Author comment:

First we would like to thank Anonymous Referee #1 for the very useful comments and detailed corrections, which we found very constructive and helpful to improve our manuscript.

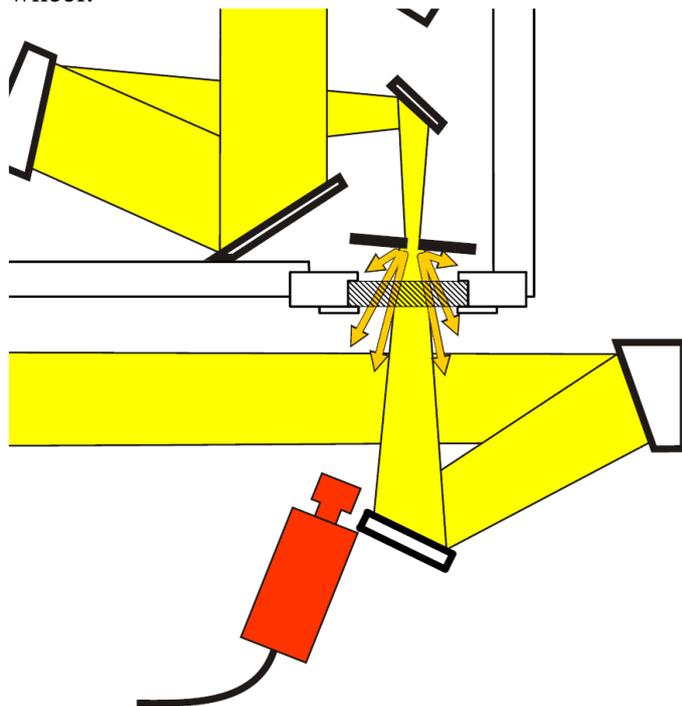
Page 4870, line 8 and Figure 4: It is not clear from the figure how the solar beam is falling on the camera or how the “input side of the field stop wheel” is recorded. Explain and show in the optical diagram.

The solar beam is not falling directly onto the camera. Instead, it records the radiation which is scattered back from the input aperture wheel without affecting the spectrometers wanted signal. Therefore we added the following sentence into the paper:

“The wanted signal used by the spectrometer is not affected by the camera.”

In addition, to illustrate how the light is falling onto the camera, we modified the following detail of Fig. 4 to clarify that the camera records radiation backscattered from the aperture wheel:
